AA 57-06 Cedar Hill
sub

Re: Cedar Hill Planned Unit Development Sketch Plan
S2007-003; P2007-0006

Re: Cedar Hill Planned Unit Development
Sketch Plan Re-submittal
Point-by-Point Response Letter
Subdivision #S2007-003
Project #P2007-0006

**CEDAR HILL
A PLANNED UNIT DEVELOPMENT
SKETCH PLAN SUBMISSION
PHASING PLAN**

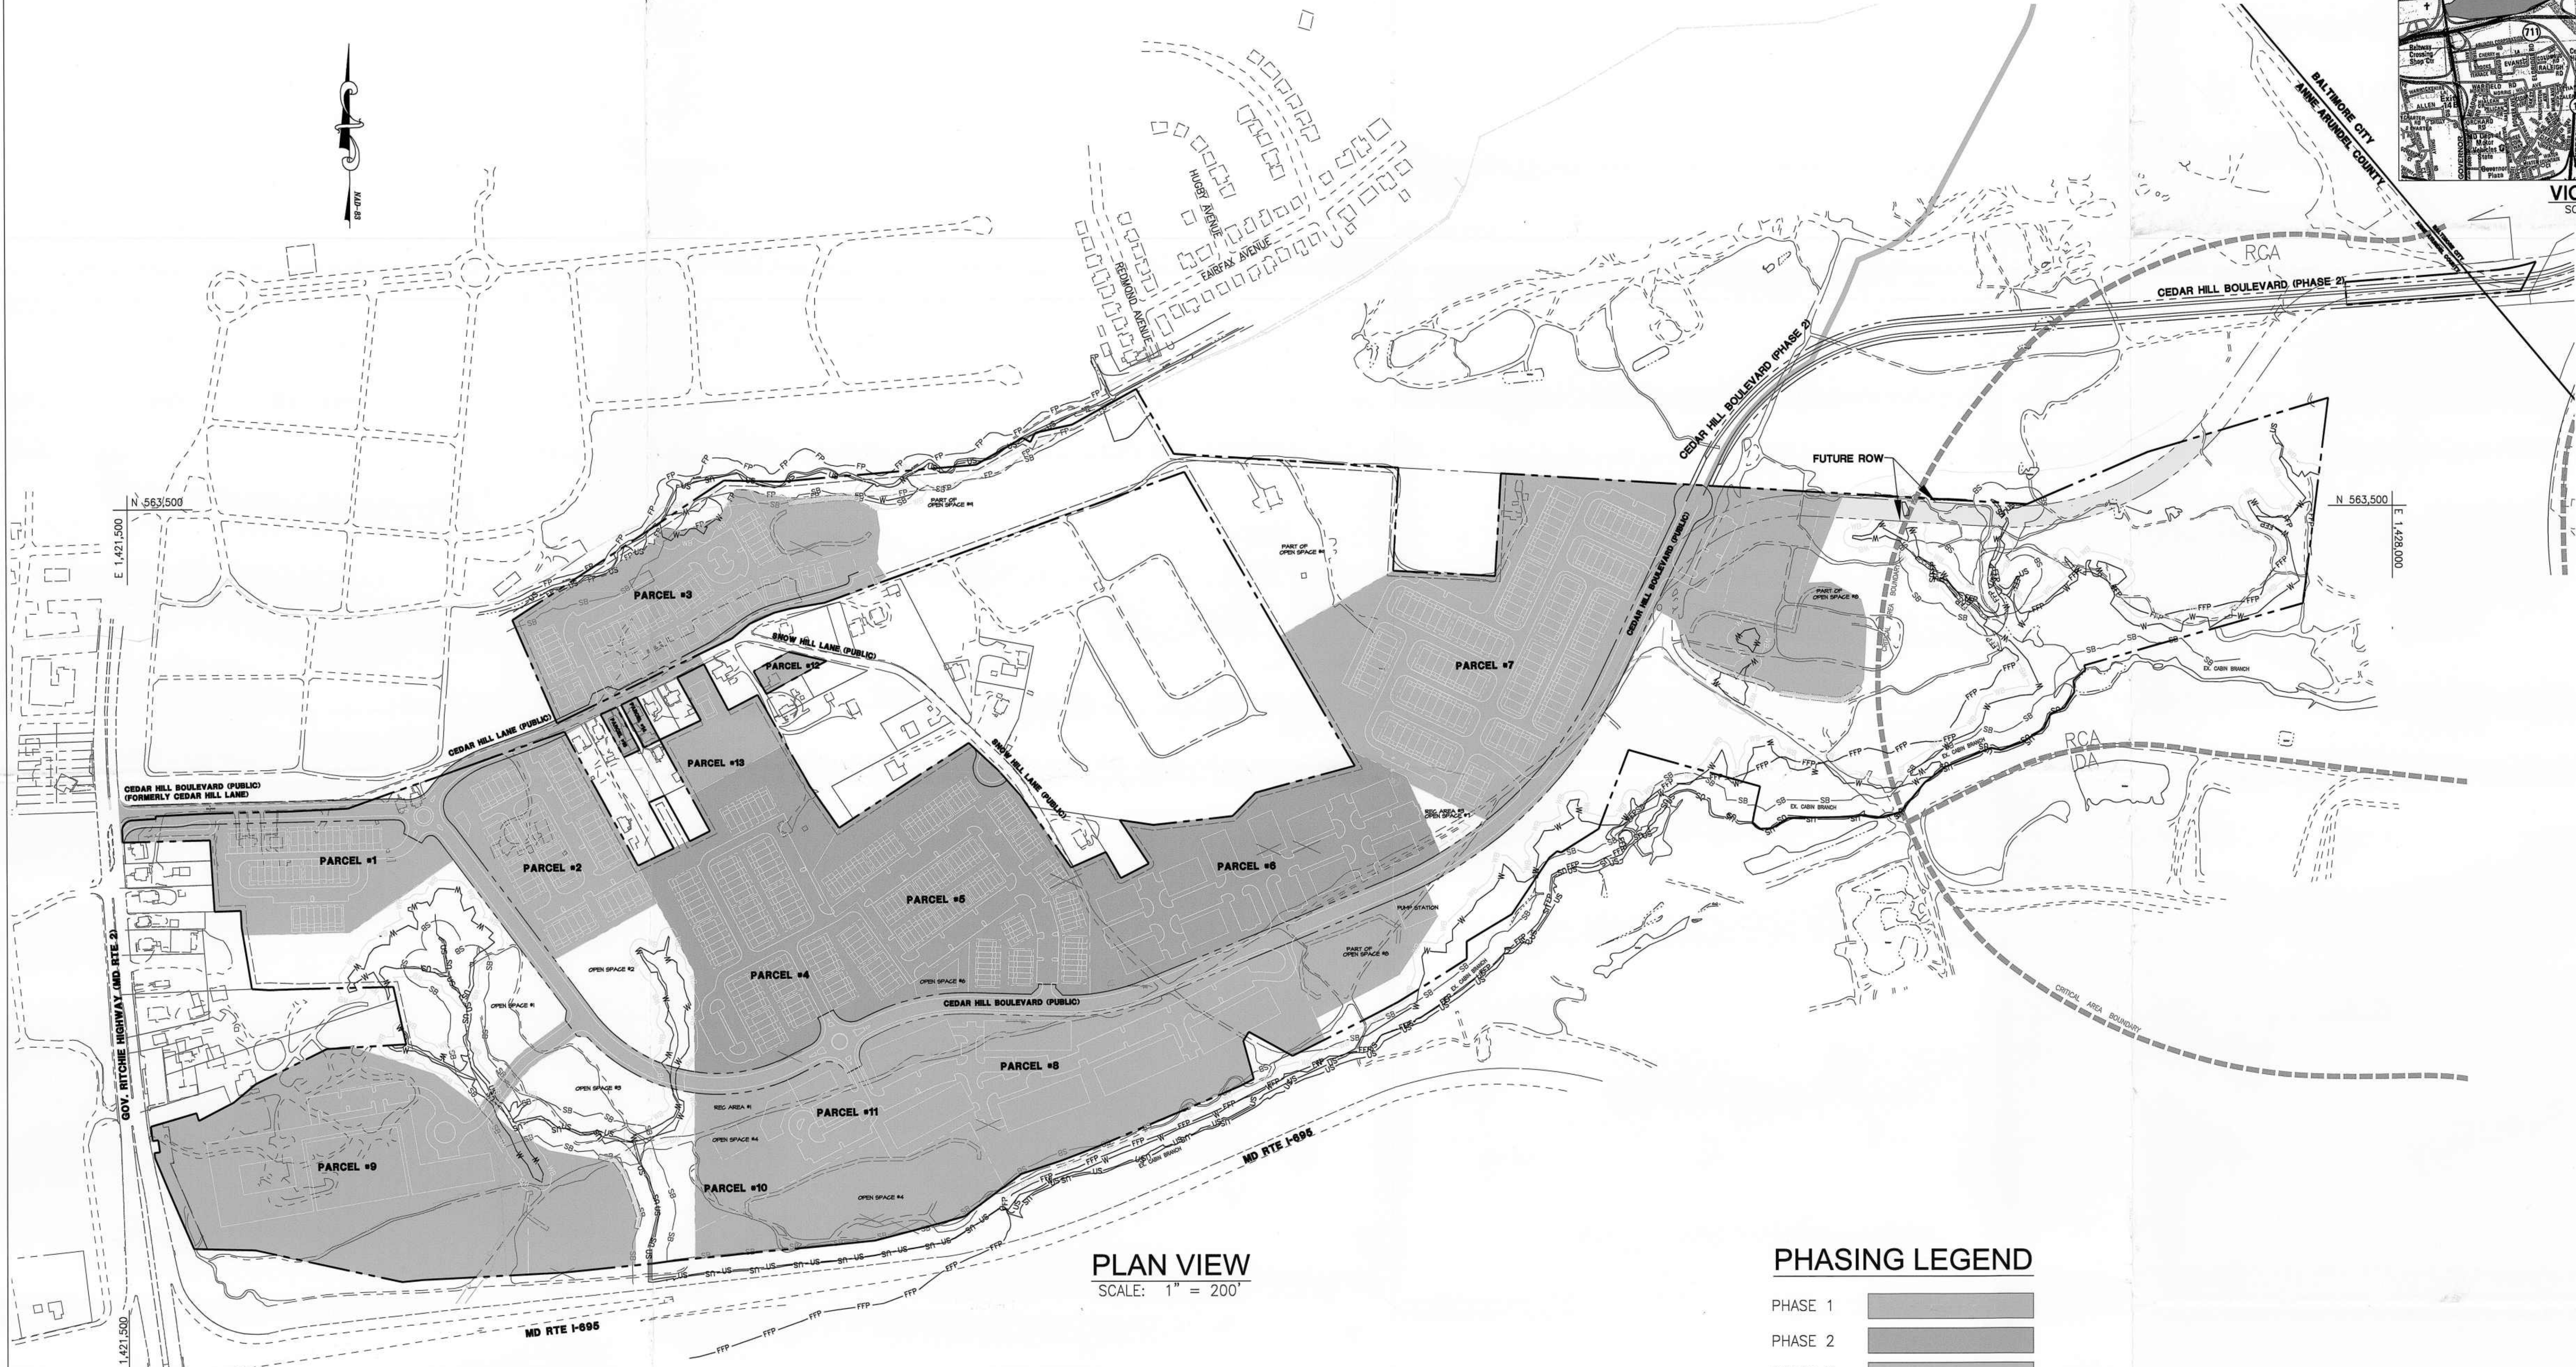
1. It is unclear as to phasing that is shown on some of the exhibits. Are there two phases or just one overall plan? The SDP cover sheet indicates Cedar Hill Boulevard connects through an adjoining property to the north that is not part of this submittal but is labeled as phase 2.

Further, the Special Exception (2006-0150-S) indicates that the project (not including the above mention W2 zoned property) will be phased in groups of 250 units to be built out through December 31, 2021. Provide a phasing plan for the units.

Response: A color coded phasing plan has been included in the re-submittal package. Currently the developer would like to separate the project into three phases as shown on the plan.

COVER SHEET
TAX MAP: 5; BLOCKS: 1,2,3 & 7; PARCELS: 20,21,23,31,34,41,42,43,53,60,
68,133,143,161,236,261,271,282,318
SUBMISSION NO. 2007-003; PROJECT NO. 2007-0065
ELECTION DISTRICT #5 - ANNE ARUNDEL COUNTY, MARYLAND - CONGRESSIONAL DISTRICT #1

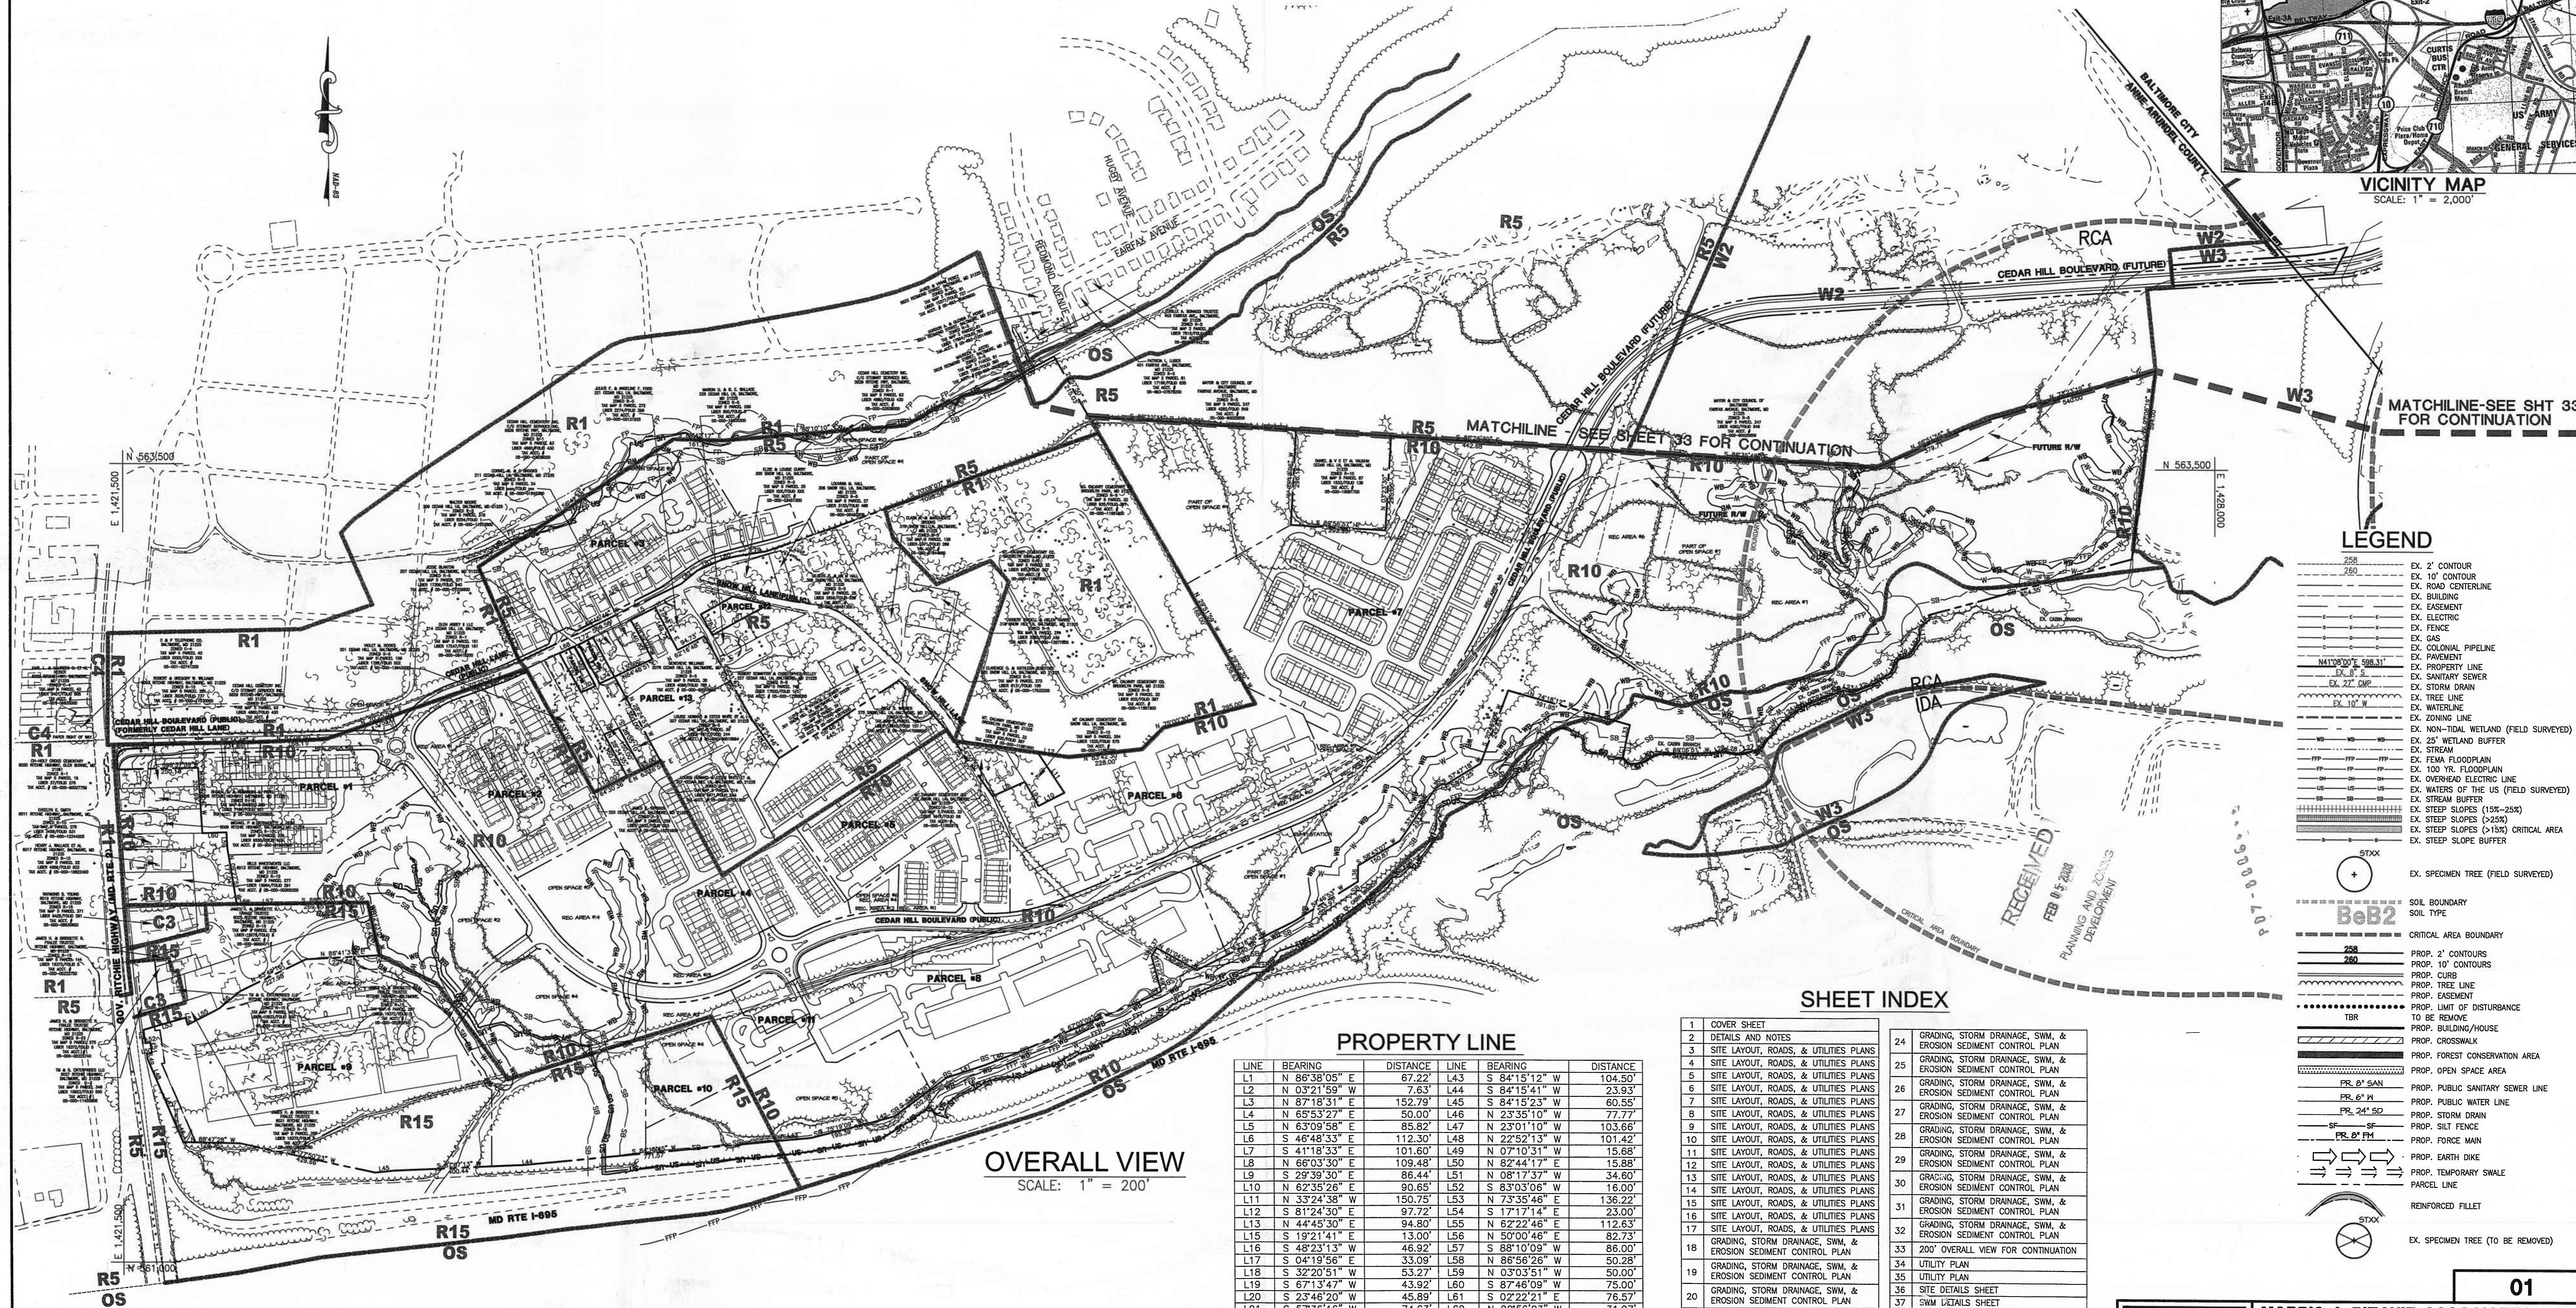
1. Clarify if the future incorporation of Parcel 247, inclusive of the proposed road alignment alternative, shall be included as part of the "existing" PUD. If so, a modification of the approved Special Exception shall be required.

Response: Parcel 247 should not be included as part of the existing PUD. The special exception for the Cedar Hill PUD included a road extension to Baltimore City that traversed through the critical area along the northern property line of the PUD. This alignment is shown on the sketch plans for future extension. The traffic study for the PUD does not require this second connection to Baltimore City. Therefore the alignment is shown for future purposes in conformance with the special exception and no disturbance is proposed with the sketch plan for this road extension. Cedar Hill Boulevard is proposed to terminate in a temporary cul-de-sac until the road extension is warranted. The future road alignment through

Parcel 247 will not be constructed as part of this sketch plan. The alignment is only shown on the sketch plan as a future alternative. In the future a special exception will be requested to include Parcel 247 in the Cedar Hill PUD. At that time the road extension that traverses through the critical area along the northern property line of the current Cedar Hill PUD will be eliminated and the Parcel 247 extension will be utilized. Showing both future alignments was agreed to by Chris Soldano in a meeting we had in May 2007. Notes have been added to the sketch plan cover sheet noting the above explanation.
